From: Joann Minko <joannjmm@yahoo.com>
Sent: Tuesday, July 18, 2023 9:00 AM
To: Zoning <zoning@cityofmadison.com>
Subject: Concerns over 4809 hillview terrace plan

As we look more into the proposed addition, we ask that the setback decision be paused until the safety and security of the proposed retaining wall next to our property can be determined by an engineering assessment. A change in retaining wall locations will impact the garage structure and location.

Our 5 year old measuring the 4 foot retaining wall at the plot line and sidewalk

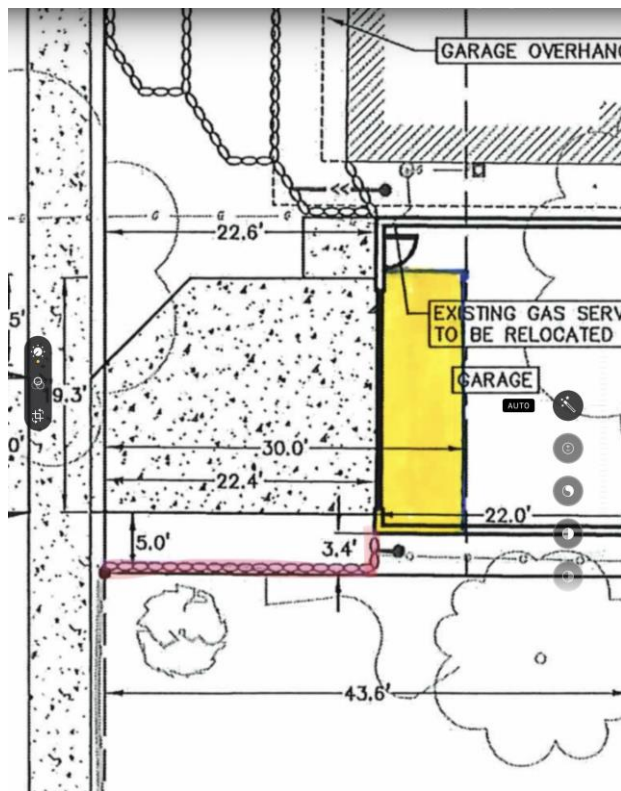
1. Per City of Madison: 'Driveways may be lined by fences or plantings that you cannot see through. Within 10 feet of the intersection of any driveway with any street-side lot line, fences or plantings cannot be more than 2 1/2 feet above curb level.'
Retaining walls follow same rules as fences

Having a 4 foot and taller retaining wall along the driveway creates a serious safety hazard for the neighborhood. Drivers coming out of the driveway would have trouble seeing people, especially those with young kids and dogs. The average kid reaches 4 feet around age 7. There are at least 13 kids under the age of 10 within a block of the proposed driveway plus our sidewalk frequently is used by people walking with kids and/or dogs. People walking along the sidewalk would be unable to see someone backing out of the proposed driveway until the car nearly reached the sidewalk. The steepness of the sidewalk would make it even more dangerous for little kids using balance bikes out on a walk with their families or parents using strollers as it would take longer for them to stop. As well, this would cause us to be out of compliance with Madison driveway viability and liable to fines and such for at least 5 feet along the street, under the current plan.
